**WORK PLAN
REPAIR OF SHORELINE EROSION
REVISION NO. 1**

**GRATWICK-RIVERSIDE PARK SITE
NORTH TONAWANDA, NEW YORK**

Reference No. 7987

figure 2.2
 SITE LAYOUT
 SLOPED BANK STABILIZATION REPAIR
 GRATWICK-RIVERSIDE PARK SITE
North Tonawanda, New York

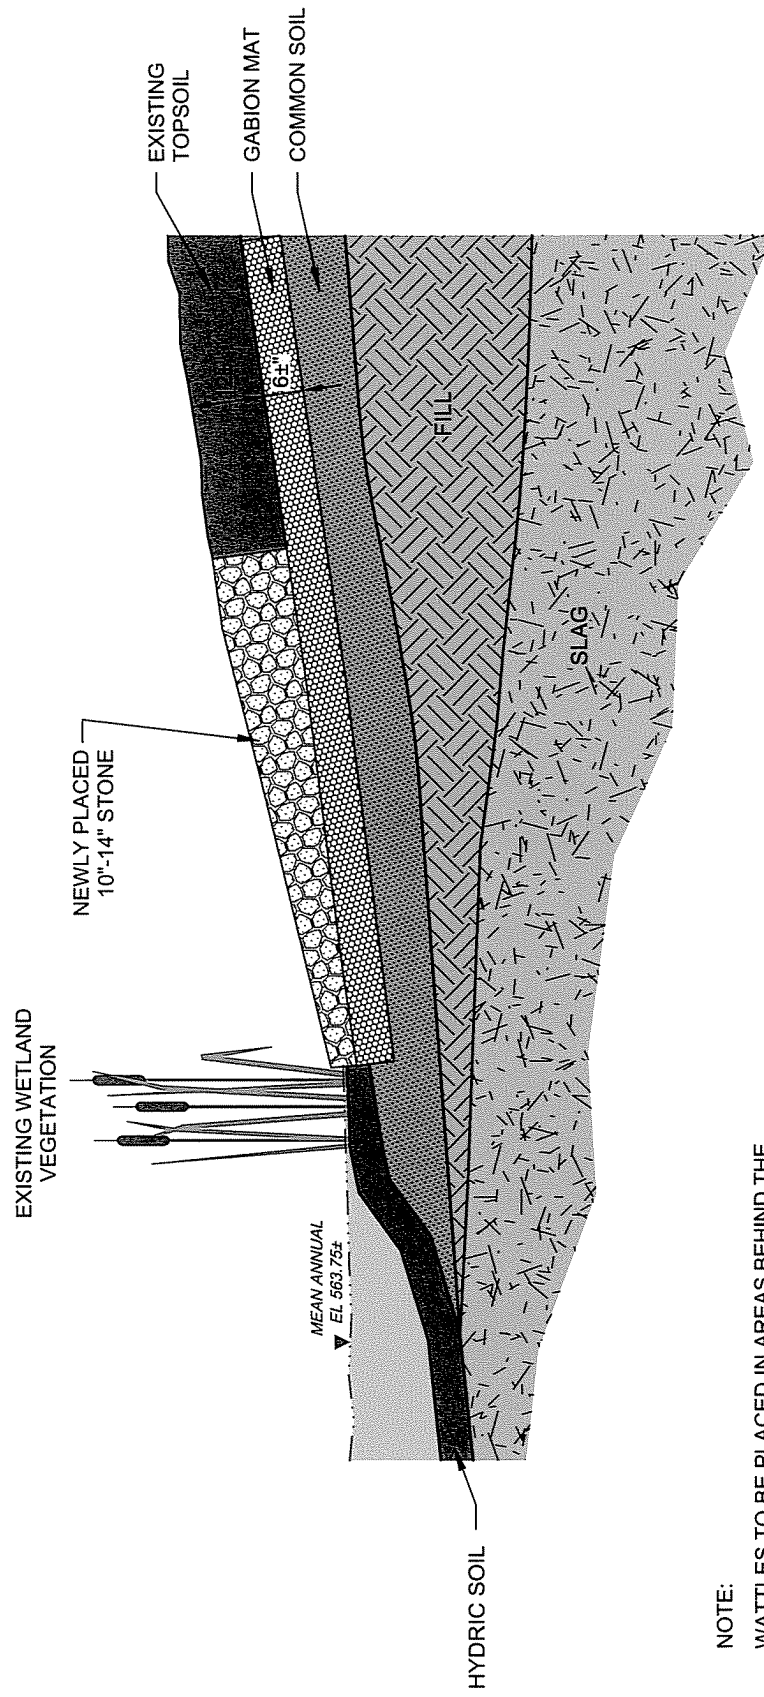
Also shown on Figure 2.2 are the areas where erosion of the overlying topsoil has occurred. It is noted that the underlying gabion mat and riprap contained within the gabion mat are in place and continue to prevent erosion of the underlying shoreline soil; thus protecting the constructed remedial components.

The width of the soil erosion ranges from 5 to 20 feet with an eroded area of approximately 4,640 square yards. The eroded area typically ends on the sloped bank at an erosion face which is on the order of 12-inches high.

NOTE:
WATTLES TO BE PLACED IN AREAS BEHIND THE
ROCK ISLETS WHERE EROSION WIDTH > 6 FEET.

figure 2.3
REPAIR WITH ROCK ONLY
GRATWICK-RIVERSIDE PARK SITE
North Tonawanda, New York

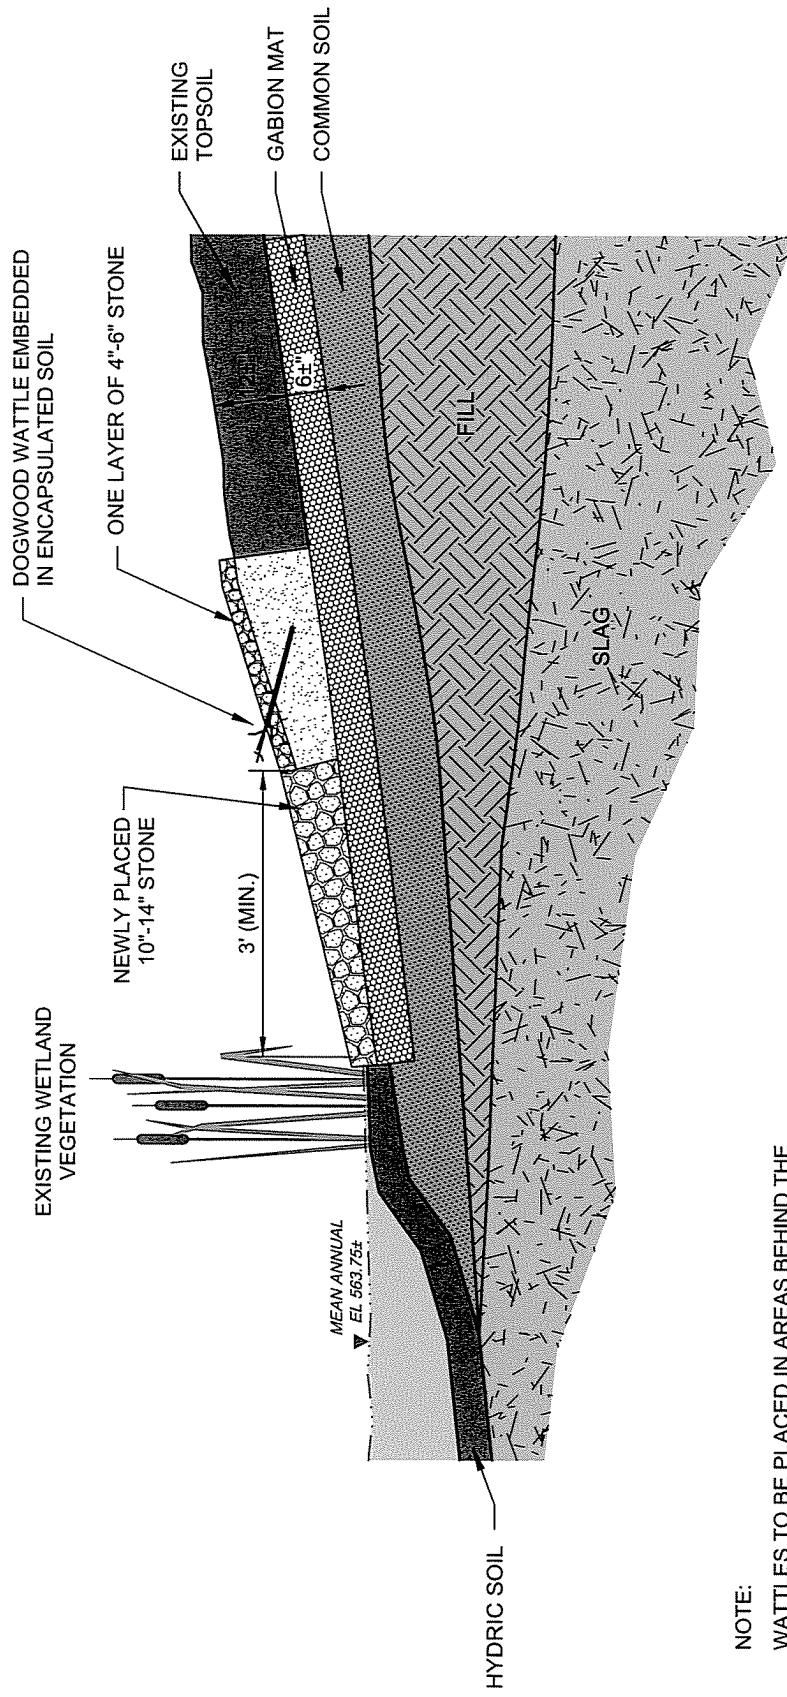
Medium riprap will be placed on top of the exposed gabion mat/riprap using a Gradall™ or similar type of equipment. The thickness of the riprap will be approximately one rock thickness (10 to 14 inch) where the repair meets the existing face

of the eroded topsoil to at the water's edge (see Figure 2.3). Thus, the average thickness of the riprap will be approximately 12 inches.
